Informal document No. GRRF-56-9

**PROPOSAL FOR AMENDMENT OF TRANS/WP.29/GRRF/2002/17/Rev.3**

(Run flat tyre - Zero pressure detection devices)

Transmitted by the expert from Japan

Receiving Performance of Direct Type  
(Bench Test Results)

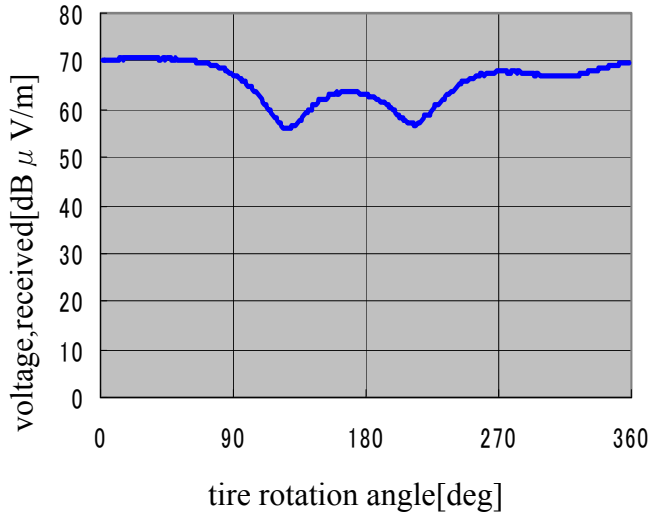
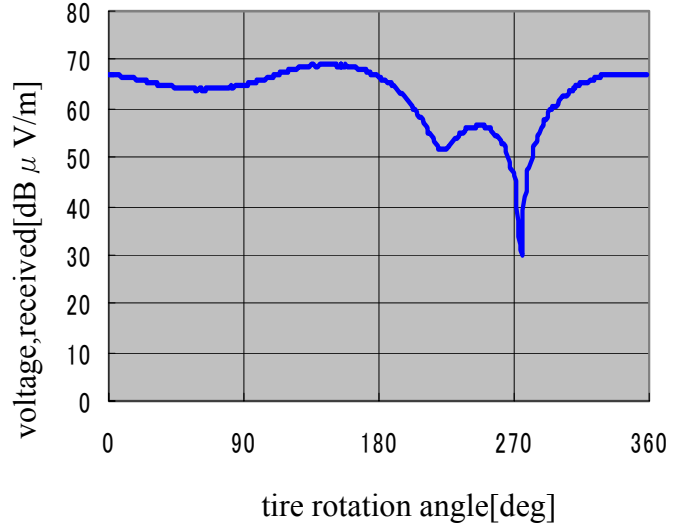
According to the investigation, for the typical direct type when the vehicle is operated at speeds in the range about 5 km/h -40 km/h transmitter interval is generally about 1 hour and the condition is detected within about 1 hour.

Therefore the direct type detects within about 40km when the vehicle is operated at low speeds (less than about 40km/h) and the run-flat tyre durability performance for 80km at 80km/h was prescribed on the previous UK draft.

When the vehicle speed is in the range 40 km/h - 100km/h, transmitter interval will be about 1 minute and the condition will be detected within about 10 minutes.

When the vehicle speed is over 100km/h transmitter interval is same 1 minute, but it has not been possible to find sufficient data for fixing the time to detect.
